MEMORANDUM

DATE: March 10, 2015

RE: 79 Church Hill Road Proposed Development Review

FIGURE 1

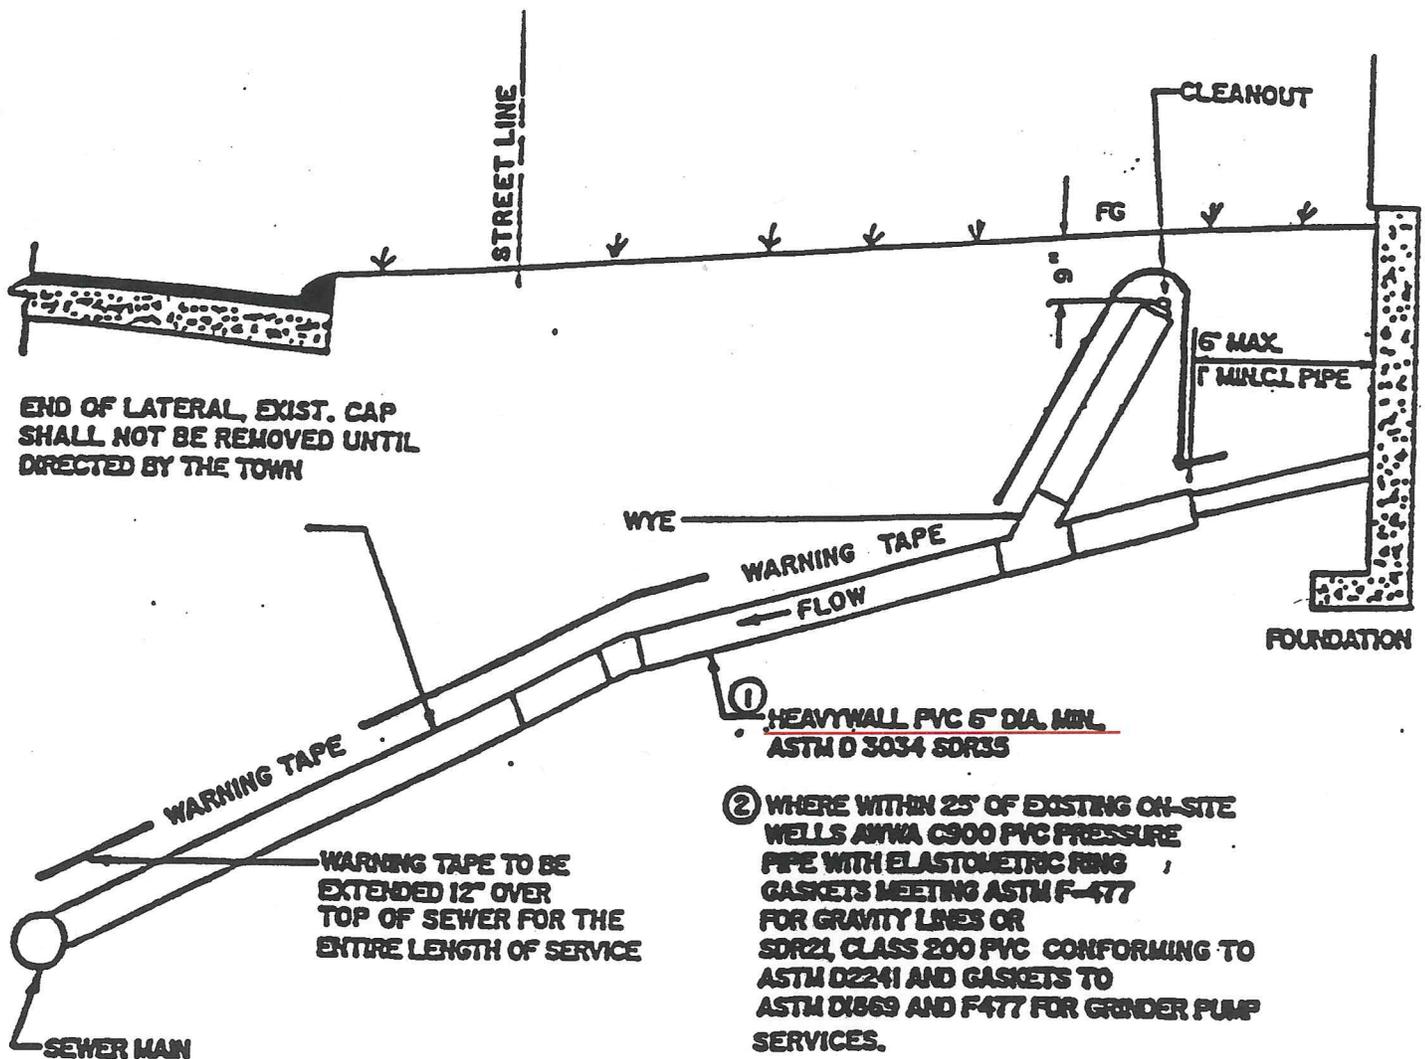
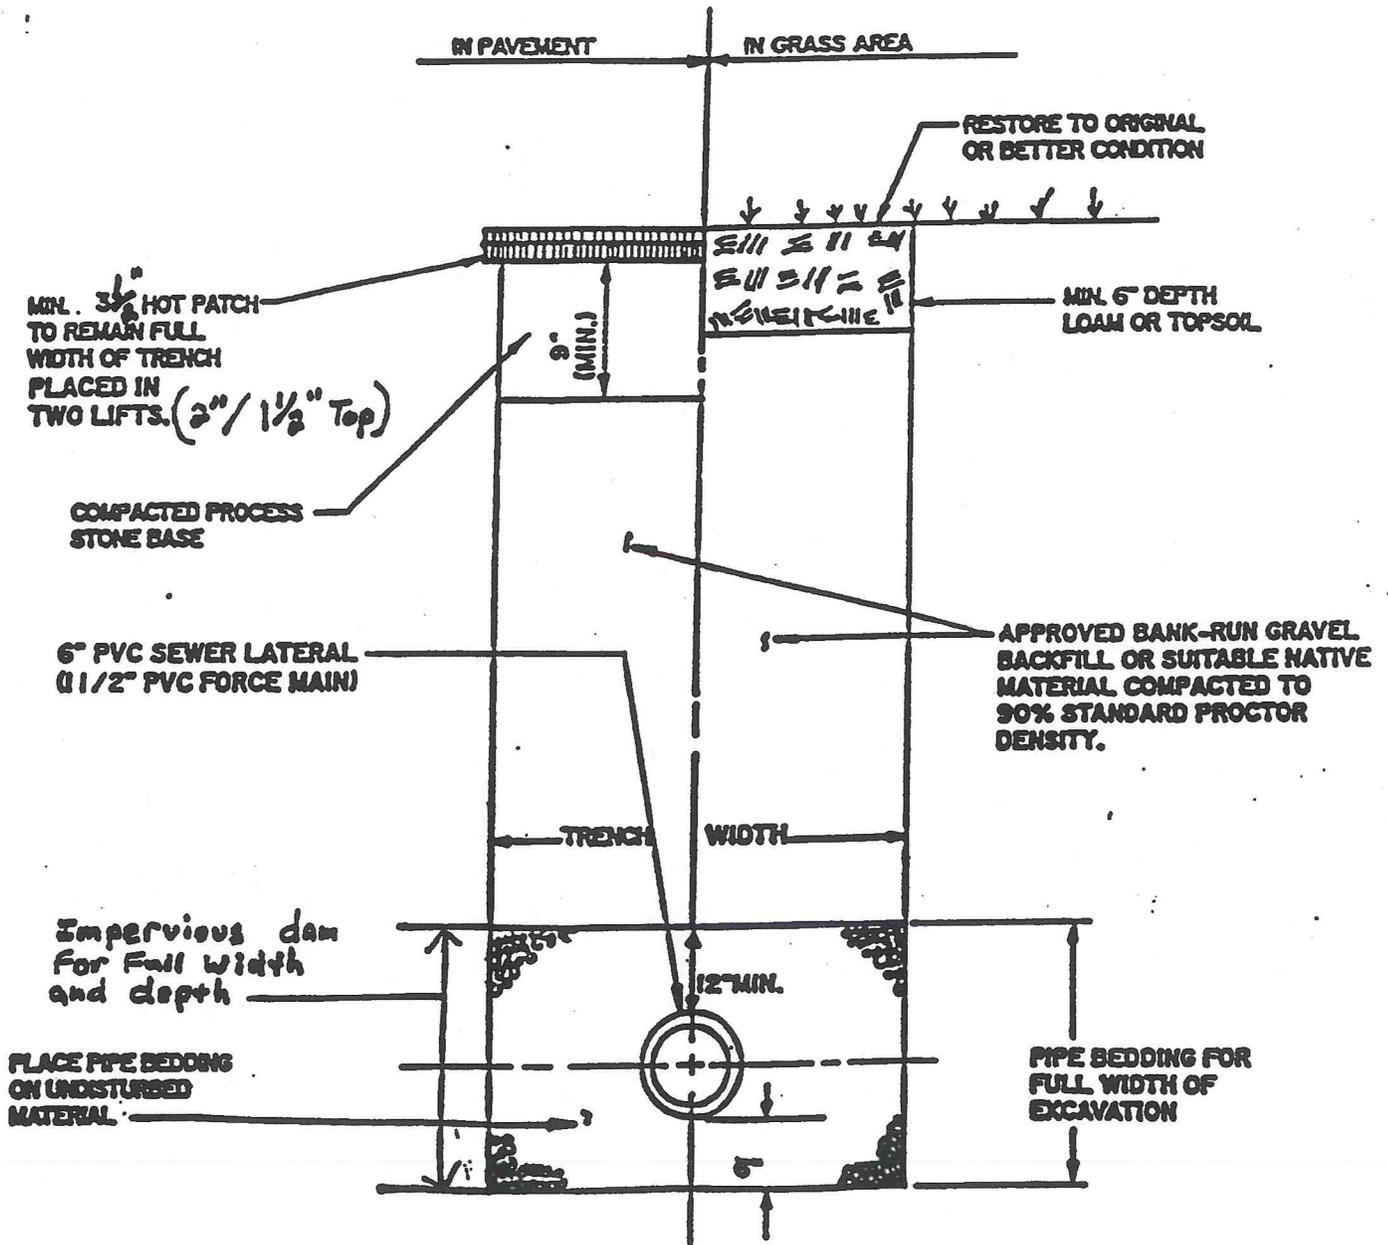
1. Basis for request (1) – There exist two (2) 6-inch laterals at the subject parcel as presented in **Exhibit 1** to service the subject parcel, not two 8-inch laterals as is asserted in the letter. Throughout the Newtown centralized sewer system the minimum pipe size for a service connection (a.k.a. lateral) is 6-inches in diameter for maintenance purposes and to minimize clogging, based on published literature (see **Exhibit 2** – "Metcalf and Eddy Wastewater Engineering: Collection and Pumping of Wastewater" p.109). Therefore there was no intent to promote development growth of the subject parcel, based on the size of the service connections provided. The minimum 6-inch lateral diameter is also presented on the Newtown DPW standard connection details Figures 1,2 for sewer connections as presented as in **Exhibit**

- 3 and the “Town of Newtown Preliminary Design Report Newtown Sewerage System, January 1994, 92-248” Design Criteria Section 8.A **Exhibit 4**. It is common practice to provide a minimum 8-inch sewer pipe, manhole and 8-inch minimum stub outside of the state right-of-way to provide public sewer connection for anticipated significant future development. If the intent was to sewer areas beyond the existing buildings, a minimum 8-inch pipe, manhole and minimum 8-inch stub would have been provided at the subject parcel.

PUMP PERFORMANCE CURVE

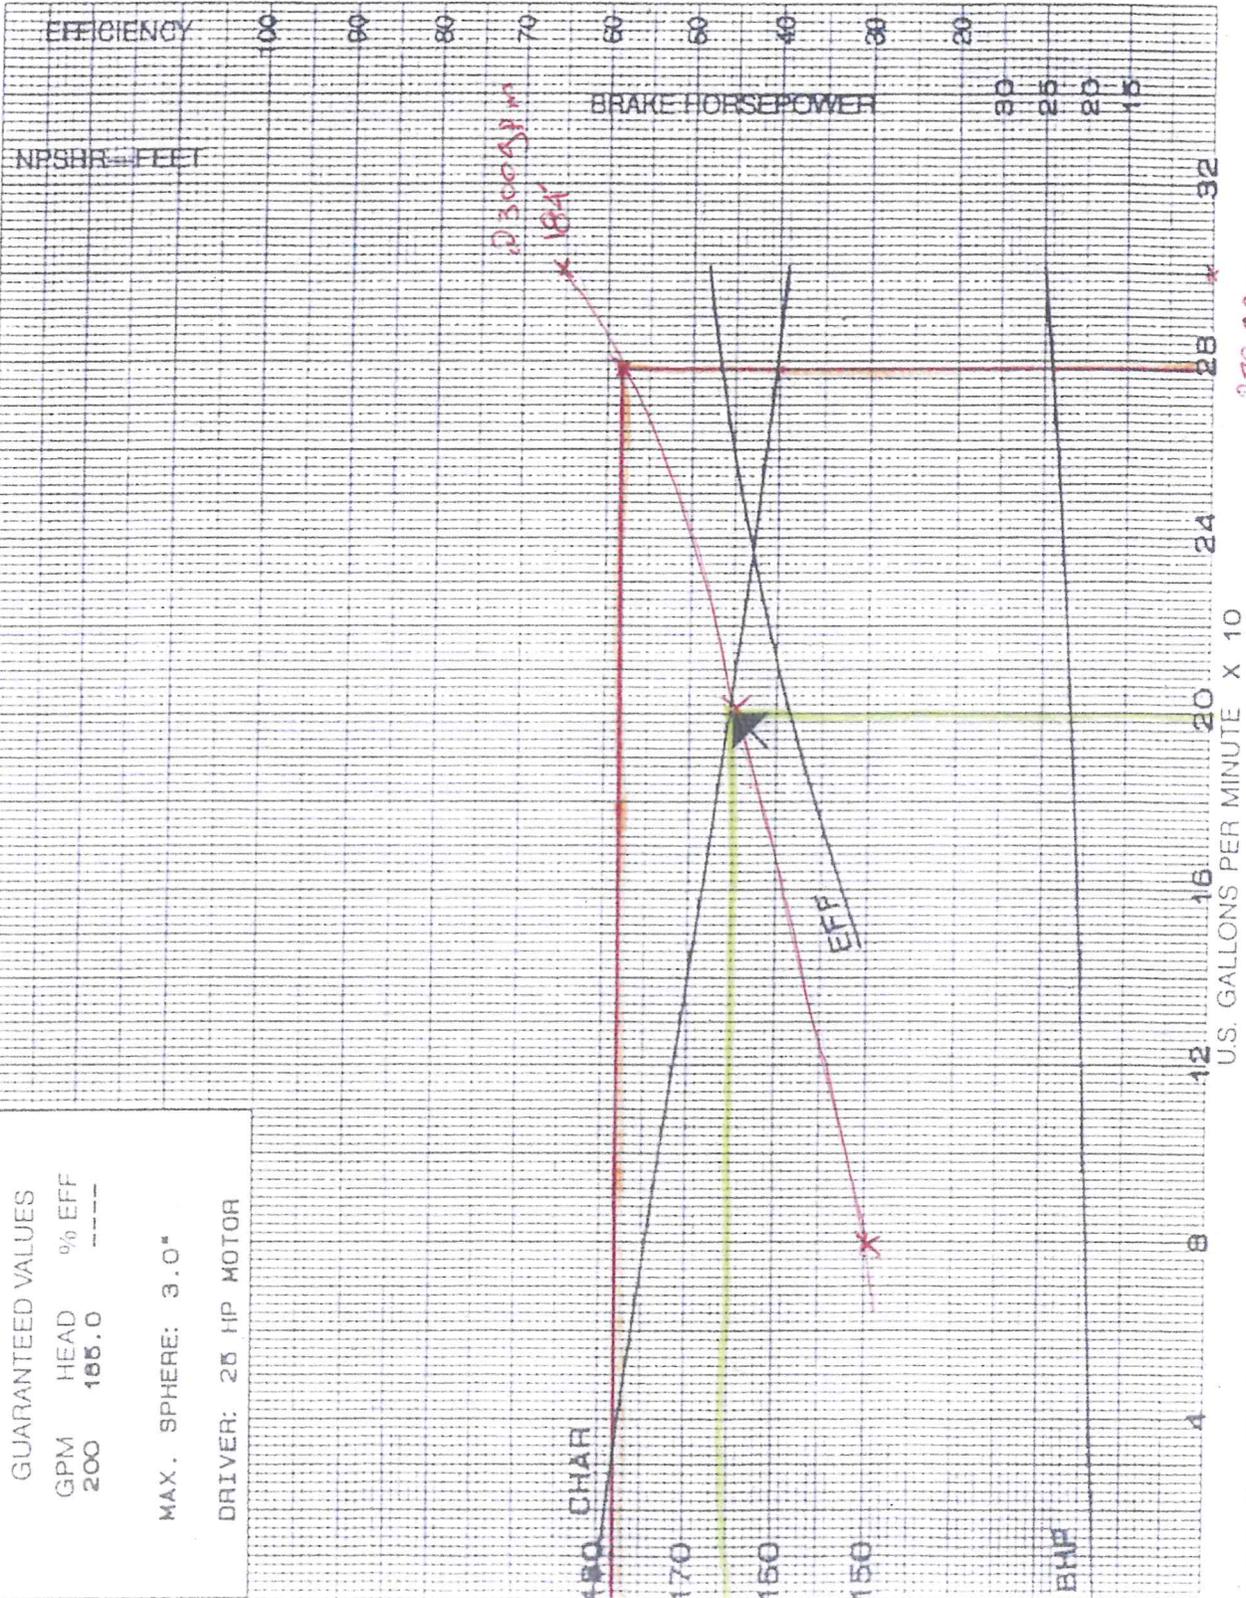
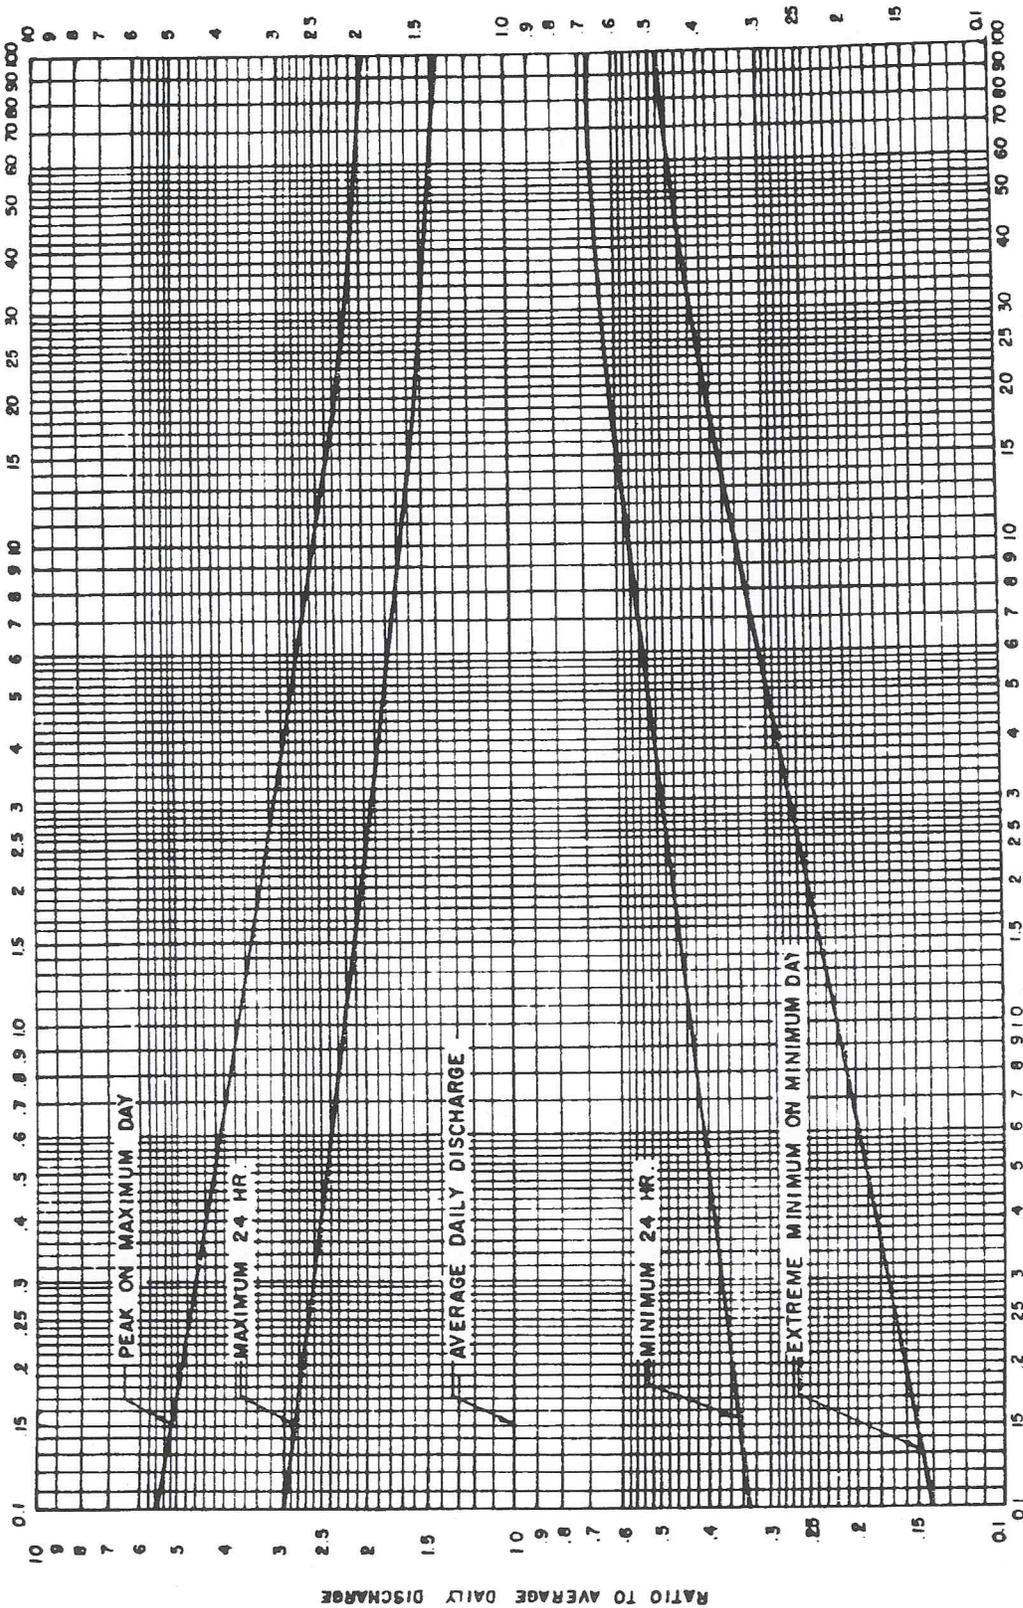
Existing
Existing + Proposed Church Hill Rd
Therefore, Existing pump can not handle the additional 107gpm @ High static head
